Re: WindingWalk PUD, PCD# PUDSP-18-002
The Enclaves at Stonebridge PUD, PCD# PUDSF-18-003
WindingWalk Filings 1, PCD# SF-18-002

This letter responds to the May 14, 2018 review letter from the Colorado Geologic Survey relating to the above referenced projects.

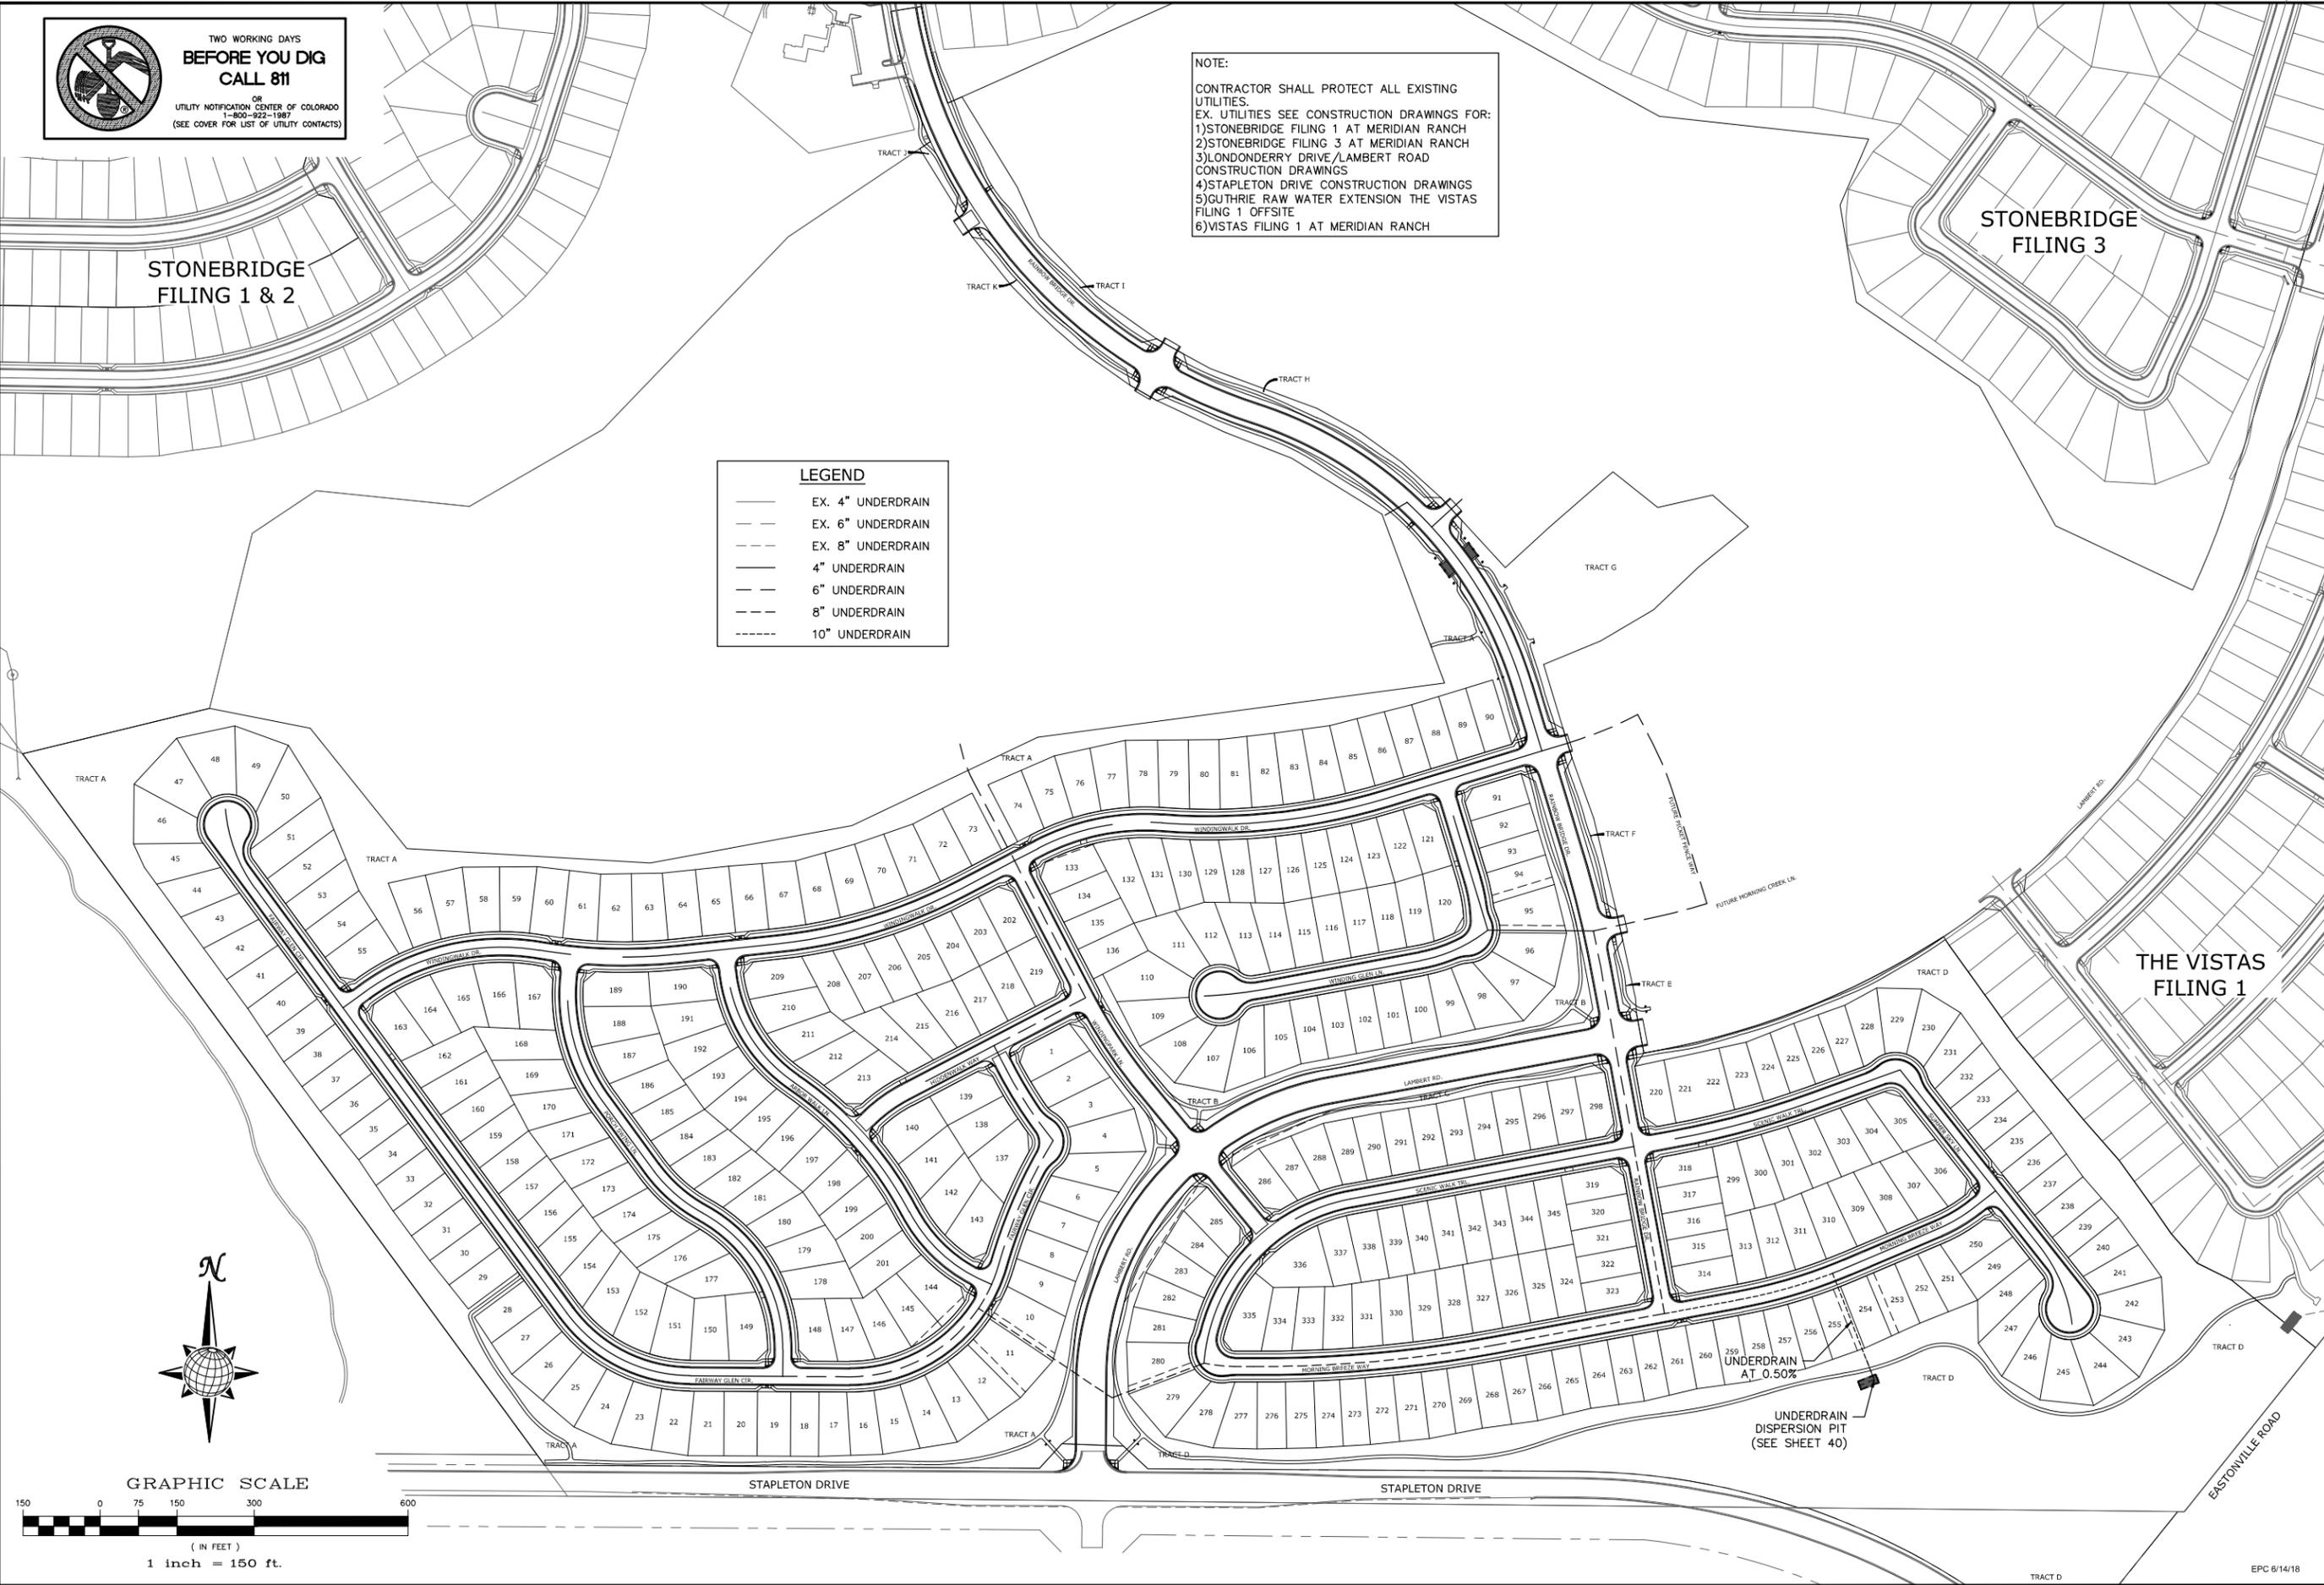
Shallow Groundwater

- The Meridian Ranch project has an extensive underdrain system capable to mitigate any shallow groundwater encountered. The underdrain system is included in the street and utility improvement plans and will be installed with the sanitary sewer. Cleanouts are placed at every sanitary sewer manhole for proper maintenance. A structure is provided at the outfall of each underdrain system to promote infiltration of the groundwater per Upper Black Squirrel Groundwater District and State of Colorado Groundwater Commission requirements. See the attached excerpted sheets from the approved construction drawings.
